**Application by National Highways for the Lower Thames Crossing
Response to The Examining Authority's written questions and requests for information
(ExQ2) Issued on 10 October 2023**

DPWLG

ExQ2	Question to:	Question:
4.	Traffic and transportation	
4.1	Traffic modelling	
Q4.1.3	Applicant	<p>HGV bans</p> <p>In its Deadline 4 Submission 'Comments on Applicant's submissions at D3' Thurrock Council has raised concerns regarding the use of HGV bans in the Applicant's modelling [REP4-354, paras 11.2.16-23]. Can the Applicant please respond to these comments?</p> <p>DPWLG Response:</p> <p>DPWLG share the concerns of Thurrock in this regard. During pre-application discussions with the Applicant, DPWLG were assured that all relevant HGV bans (existing) were included within the modelling. If this position has changed, it clearly needs proper explanation, assessment and review.</p>
Q4.1.4	Thurrock Council	<p>Orsett Cock: local traffic</p> <p>While there are likely to be impacts on queuing and delay at the Orsett Cock Roundabout, Tables A.2 and A.3 in the Applicant's Deadline 4 post-event submissions [REP4-180] suggest that the majority of the affected movements would be accessing local rou

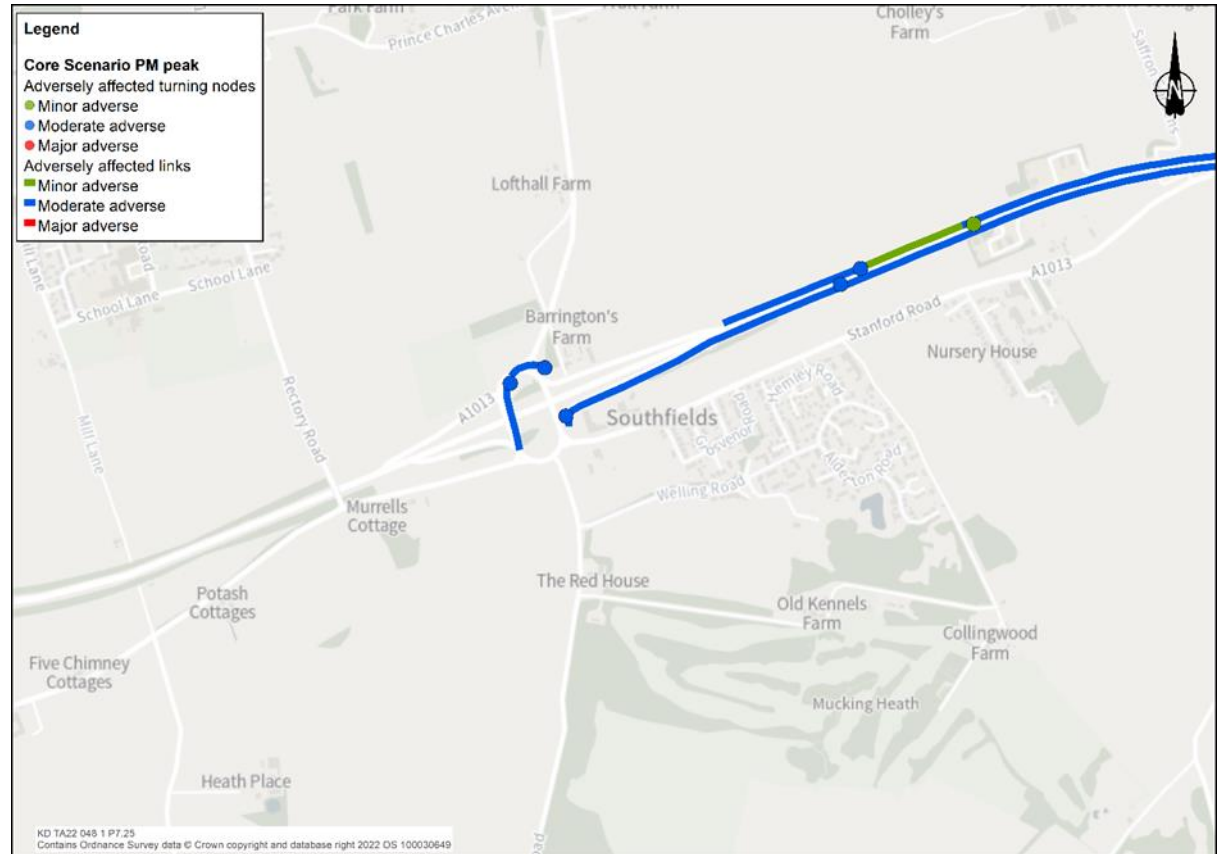
- 4) Changes in vehicle times through the junction will remain significant, particularly in the PM Peak. The A13 eastbound shows a queue of 700m in 2030 rising to over 2km in 2045. Journey time increases of at least 60 seconds are forecast in 2030 and 200 – 300 seconds in 2045. There is no reported queue on the A128 southbound which conflicts with the conclusions of the Applicant's Linsig and also LTAM modelling (see below).

- 5) This remains in conflict with the LATM outputs. The figure below was provided by the Applicant on 29th September 2023 and shows a zoomed in version of Table 7.27. It can be seen that the whilst the nodes are shown as being of moderate impact, there is no reference to the A13 eastbound approach or A128 southbound approach.
